SUBJ: Cedar Hill Road Subdivision (1512-1524 Cedar Hill)-#25-07SUBD

Reference: 1512 & 1524 Cedar Hill Road Subdivision
TMP's #39-00-00646-00-8 and #39-00-00649-00-5
Preliminary/Final Land Development Application

Pursuant to your request, Gilmore & Associates, Inc. performed a review of the preliminary submission for land development for the above-referenced project. Upon review, we offer the following comments for consideration by the Lower Gwynedd Township Board of Supervisors:

PLAN SCALE	DRAFTED BY	PROJECT MANAGER	PLAN SHEET NUMBER
1" = 40'	M.J.P.	S.A.R.	9 OF 18
	PROJECT NUMBER	DRAWING FILE NUMBER	
	6571	6571PCSM

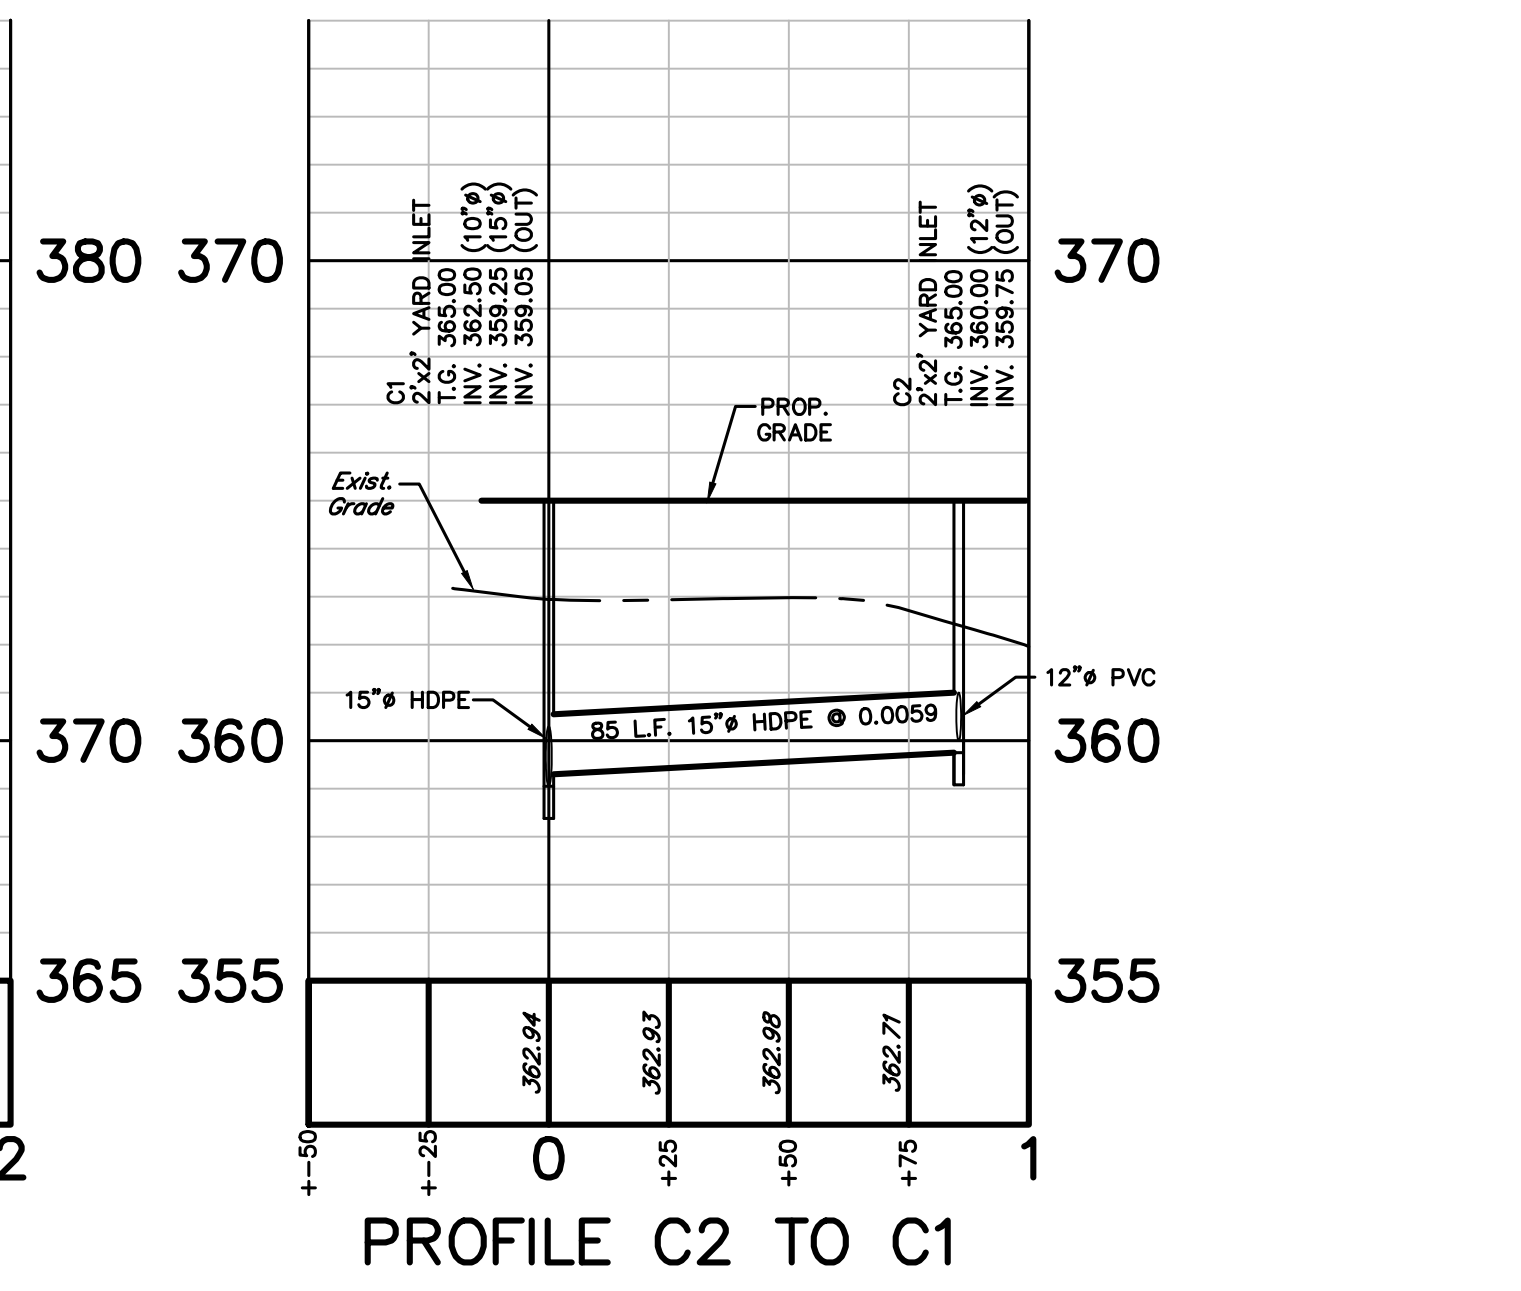
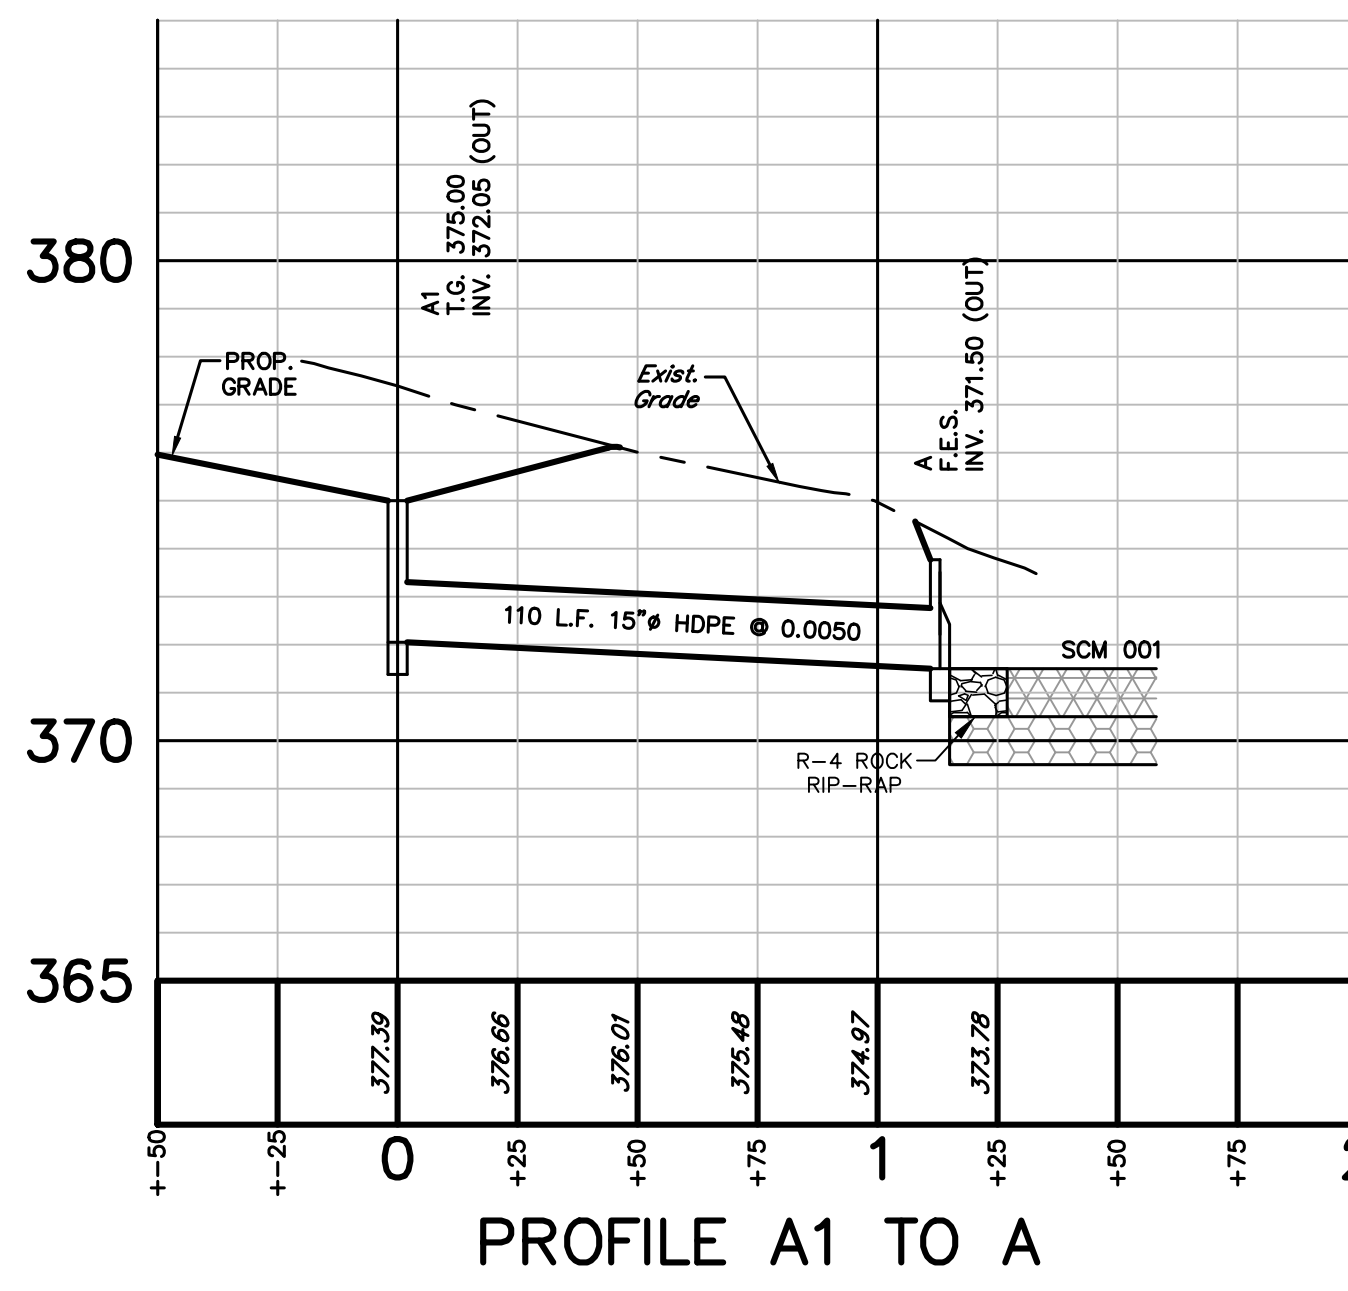
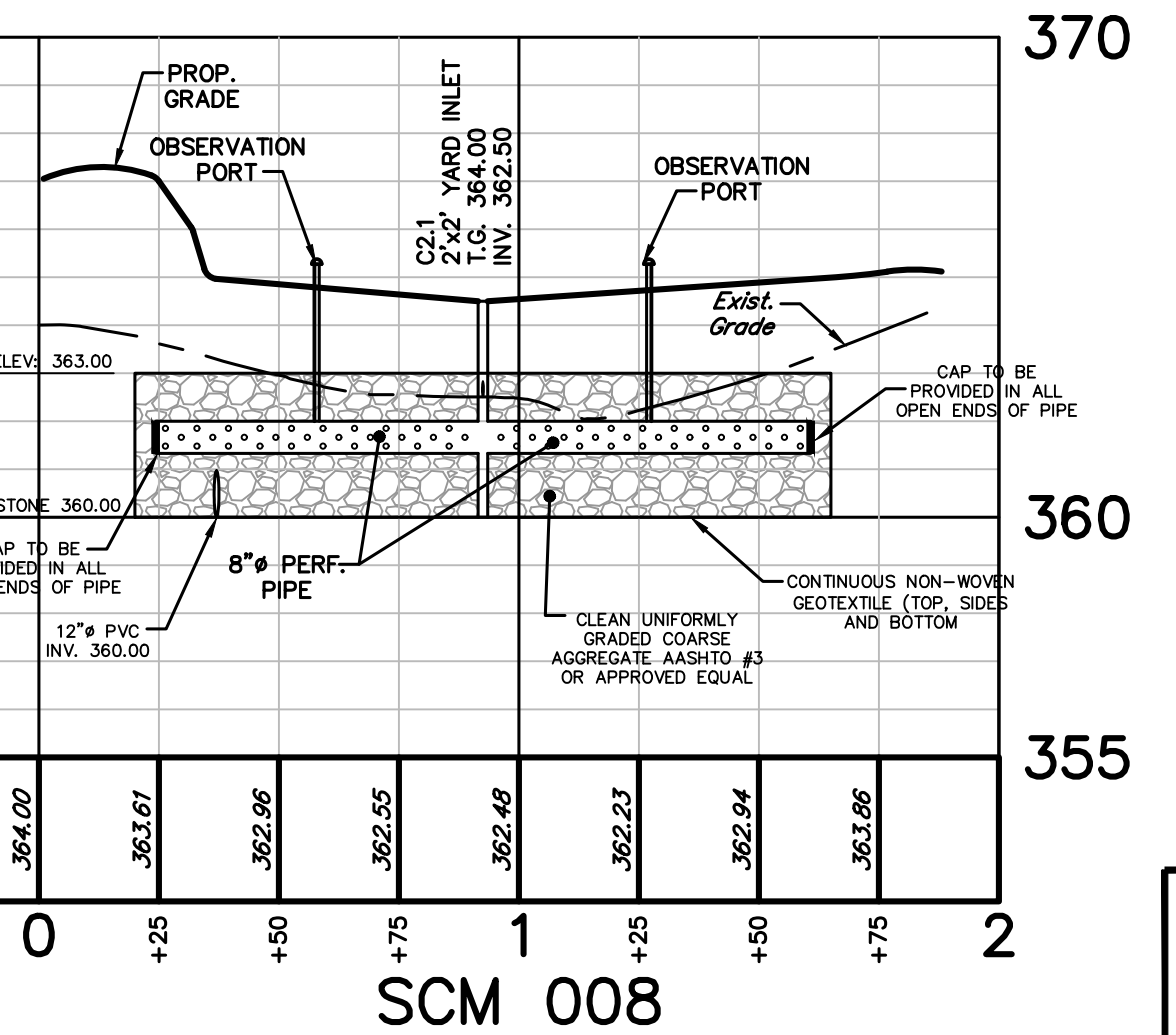
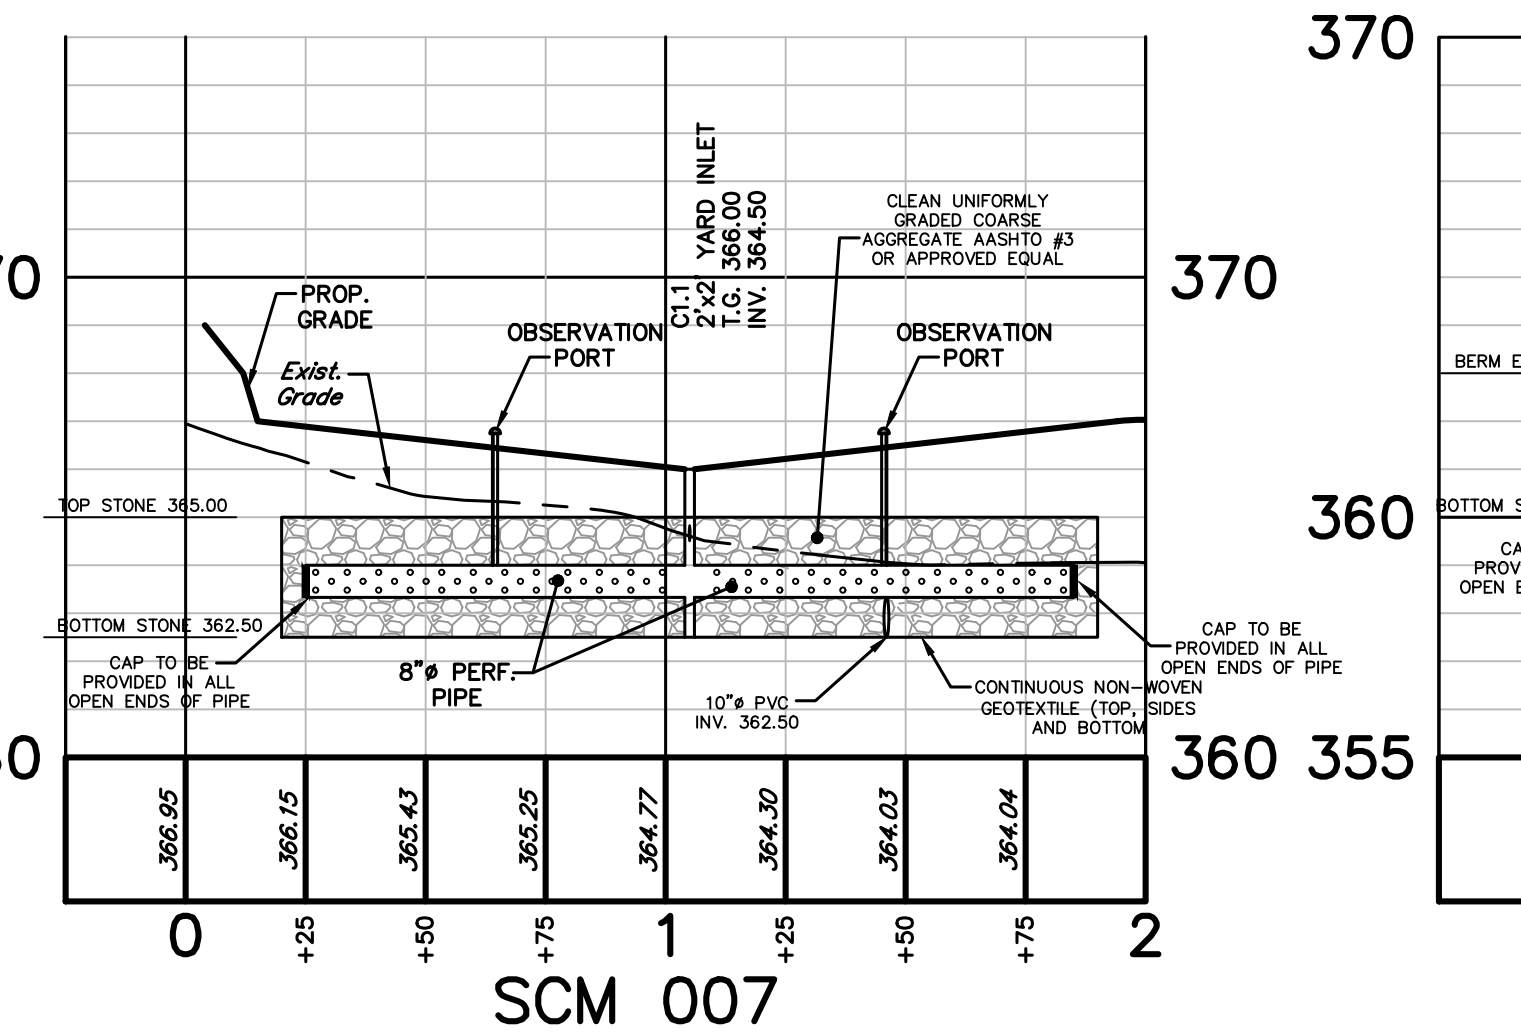
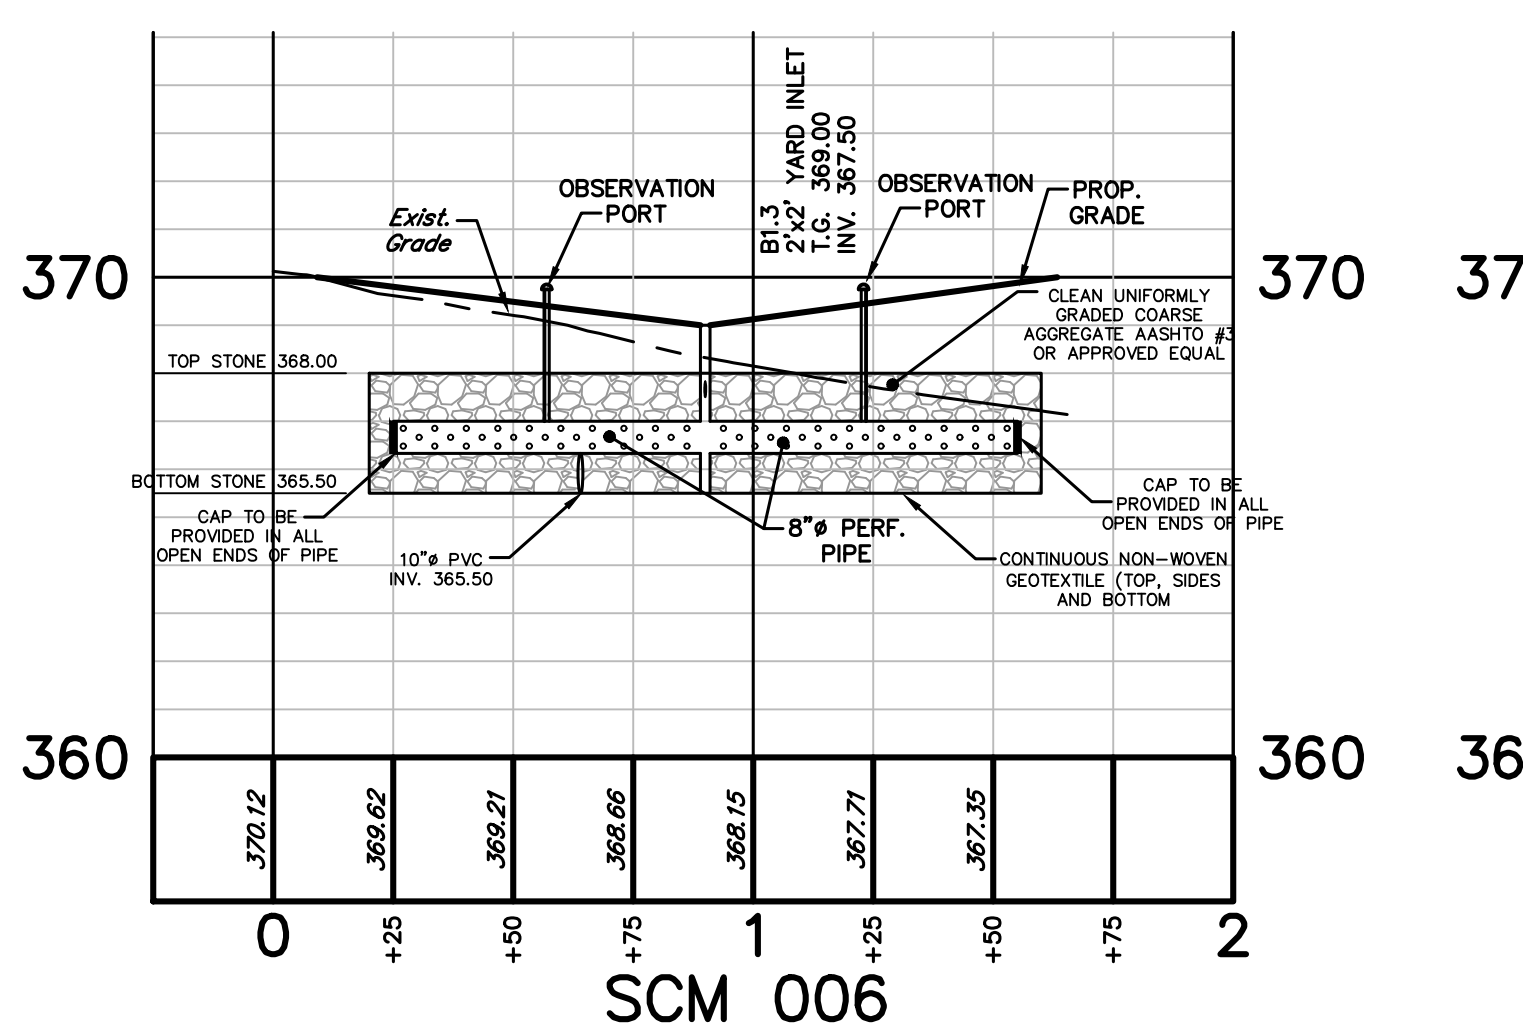
- f. The PCSM Plan (sheet 9 of 18) shall be revised so that the callout text does not overlap other linetypes for clarity.
 - g. The widths of SCM 005 & SCM 007 on the PCSM Plan (sheet 9 of 18) is not consistent with the callout and details. The Applicant shall confirm the sizes and revised the plans accordingly.
